DraftPreliminaryHRSC_CSM_FID_082416_TowerStandard.4dm - 4DIM Player
Author: Jason C. Ruf
Organization: S2C2 Inc.
Description: Draft CSM for High Resoluti...
Tower Standard Site
Lac du Flambeau, Wisconsin
Data Analysis and Data Visualization Report
August 2016
Vertical Exaggeration is 2.5x
MIP-FID above 50,000 uV
S2 C2 inc.
Elevation
Easting
MIP-FID
10,000,000 uV
3,000,000 uV
1,000,000 uV
300,000 uV
100,000 uV
30,000 uV
10,000 uV
Total VOCs
1,000,000 ug/kg
300,000 ug/kg
100,000 ug/kg
30,000 ug/kg
10,000 ug/kg
3,000 ug/kg
1,000 ug/kg
300 ug/kg
100 ug/kg
30 ug/kg
10 ug/kg
3 ug/kg
1 ug/kg
1,990,400
1,990,500
1,990,600
1,990,700
NOTES:
See Data Analysis and Data Visualization Report for data visualization details.
Inbox - Mailbox - Kady, Tom - Outlook
You are not responding to the latest message in this conversation. Click here to open it.
To... Egan, Robert
Subject RE: Recommendations for additional well locations at the Tower Standard site

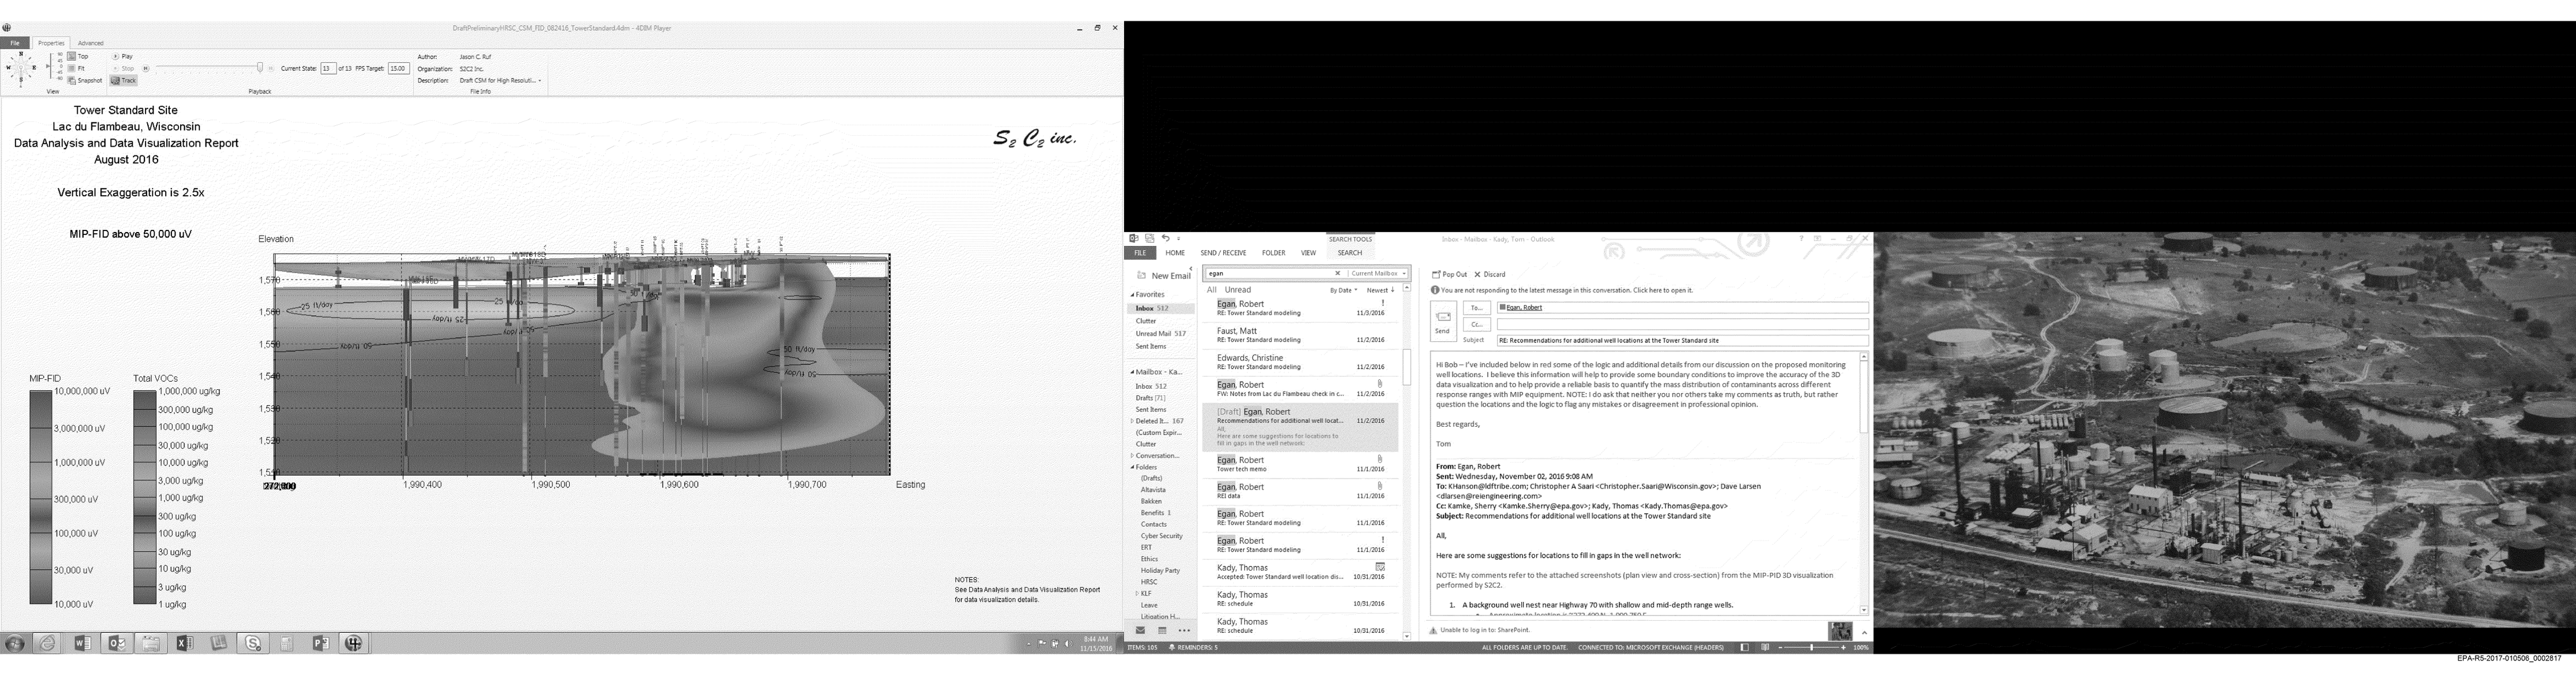
All,
Here are some suggestions for locations to fill in gaps in the well network:
NOTE: My comments refer to the attached screenshots (plan view and cross-section) from the MIP-PID 3D visualization performed by S2C2.

1. A background well nest near Highway 70 with shallow and mid-depth range wells.
Unable to log in to: SharePoint.
8:44 AM
11/15/2016
